**CITY OF FLORENCE PLANNING COMMISSION  
CITY CENTER – COUNCIL CHAMBERS  
324 WEST EVANS STREET, FLORENCE, SC  
TUESDAY, OCTOBER 14, 2025 – 6:00 P.M.  
REGULAR MEETING AGENDA**

**AGENDA ITEM:      PC-2025-36      Request for sketch plan review of Point South Townhomes, located at 3648 South Irby Street and identified as Florence County Tax Map Number 00152-01-029.**

**AGENDA ITEM:      PC-2025-37      Request for sketch plan review of Villa Toscana Townhomes, identified as a portion of Florence County Tax Map Number 00100-01-101.**

**AGENDA ITEM:      PC-2025-38      Request for sketch plan review of 262 West Cheves Street, identified as Florence County Tax Map Number 90087-01-015.**

# Attachment E: Sketch Plan

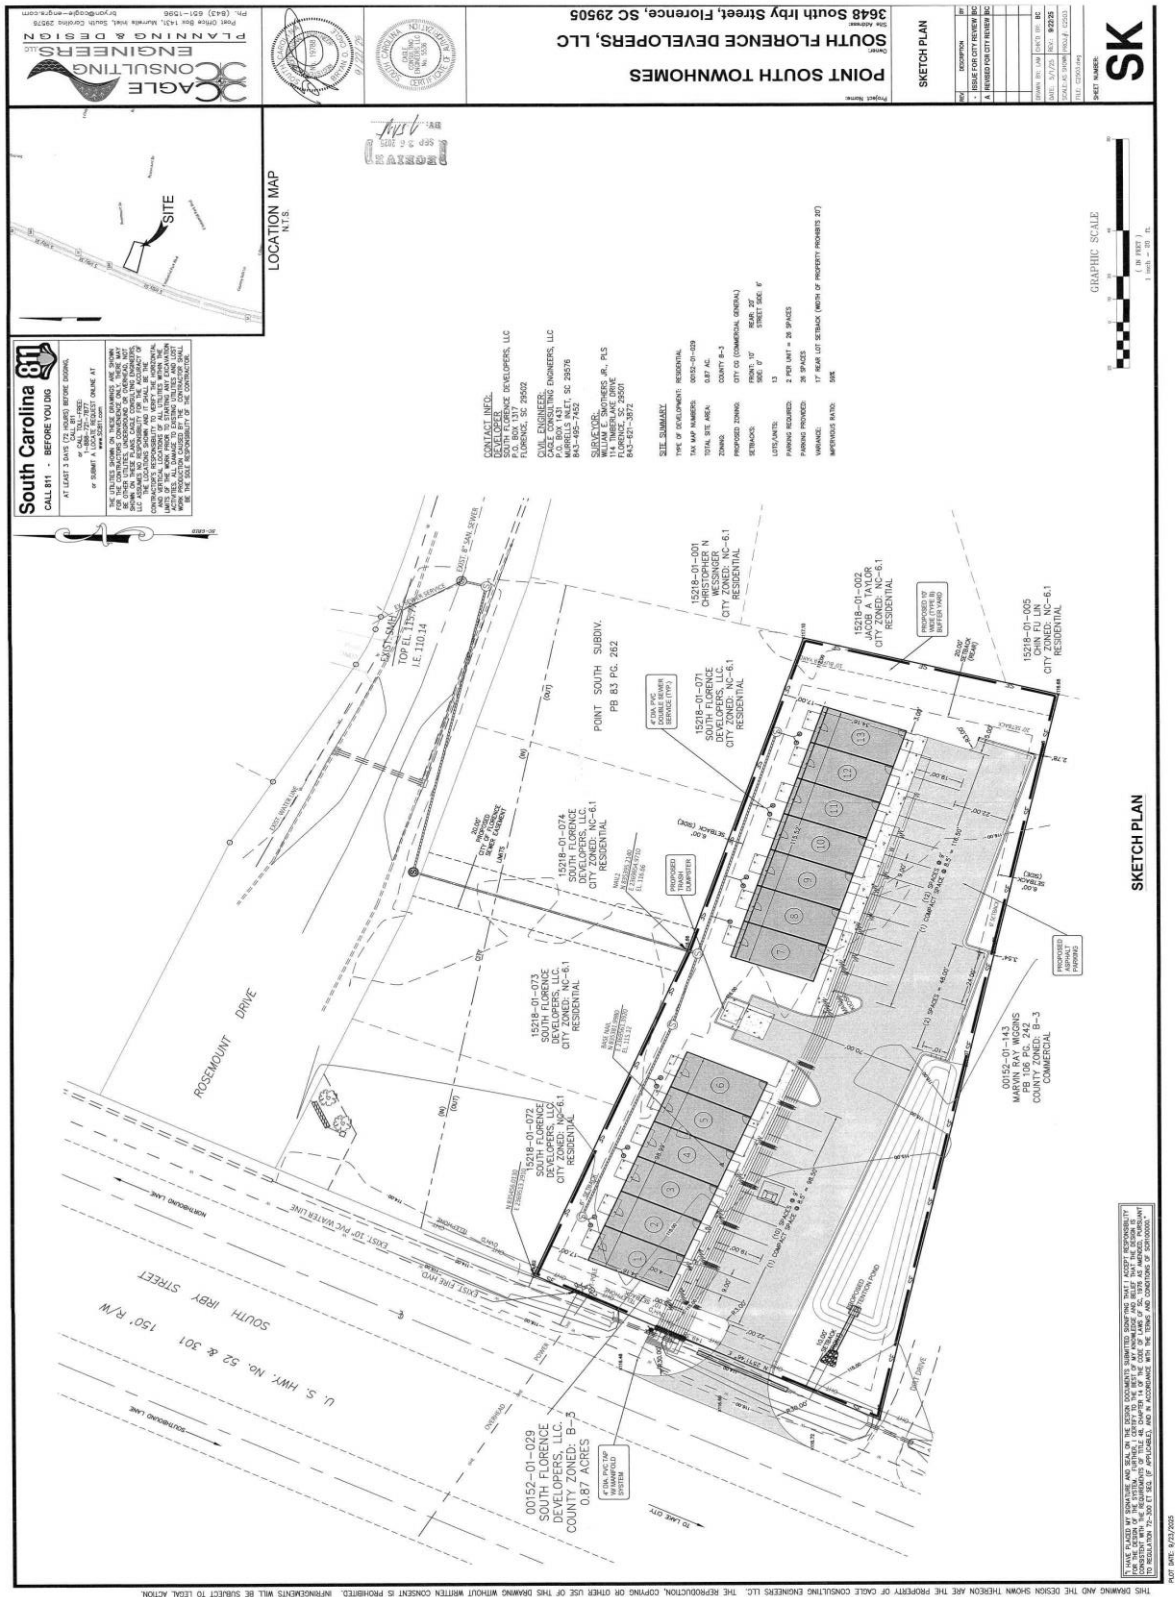
- (7) The applicant is requesting a 3' variance from the prescribed rear 20' setback for townhomes. If Planning Commission grants the variance, the townhome units would be 17' from the northern property line. If granted, this would also reduce the required 25' bufferyard as outlined in Point 8 below. Additionally, the required buffer would engulf the entirety of each unit's rear yard.

- (8) A Type C Bufferyard is required between the proposed development and the properties to the north and the east due to the disparate zoning. A Type C Bufferyard is 25' in width and consists of 3 canopy trees, 3 understory trees, 3 evergreen trees, and 30 shrubs per 100 linear feet. A canopy tree per lot is also required for each proposed townhome unit and commercial parking lot landscaping will be provided. At this time, the Sketch Plan does not show the required landscaping.

- (11) The Sketch Plan is not currently in compliance with applicable *Unified Development Ordinance* requirements. Plan review comments (attached) have been relayed to the applicant and engineer. Once the comments are addressed, a statement of compliance regarding the Sketch Plan will be prepared by staff and presented to Planning Commission.

Attachment E: Sketch Plan

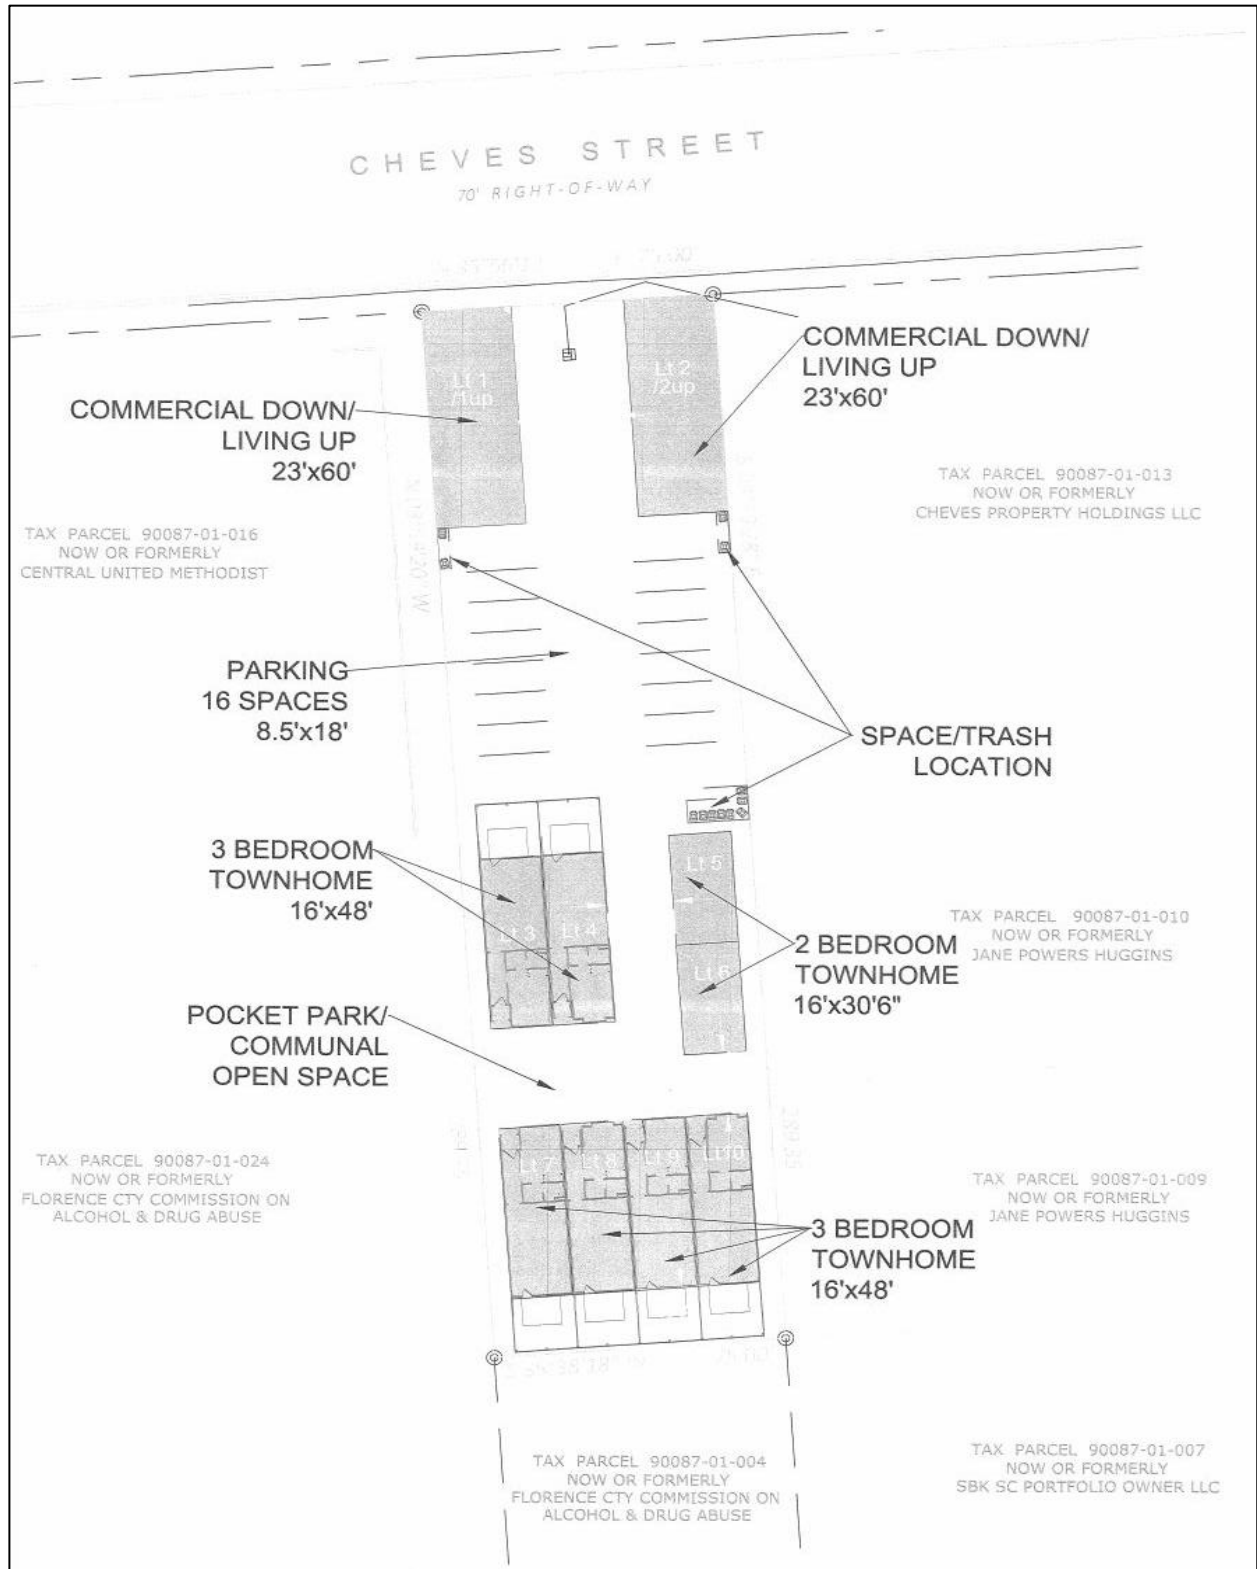
- (11) The applicant is requesting variances (Attachment F) from:
  - a. UDO Section 4-9.3.2I.1 for a reduction from the required 20' minimum distance between unattached townhome buildings down to 17'.

- b. UDO Section 1-2.8.2K8 for a variance from the standard parking space dimensions of 9' width and 19' depth to parking spaces that are 8.5' in width and 18' in depth.

- (12) The Sketch Plan is not currently in strict compliance with applicable *Unified Development Ordinance* requirements, specifically for lot area requirements; however, downtown design standards and densities allow for variability from typical townhome development standards. The development does meet the lot area requirements for the CBD district. Staff will provide a statement of compliance to present to Planning Commission.
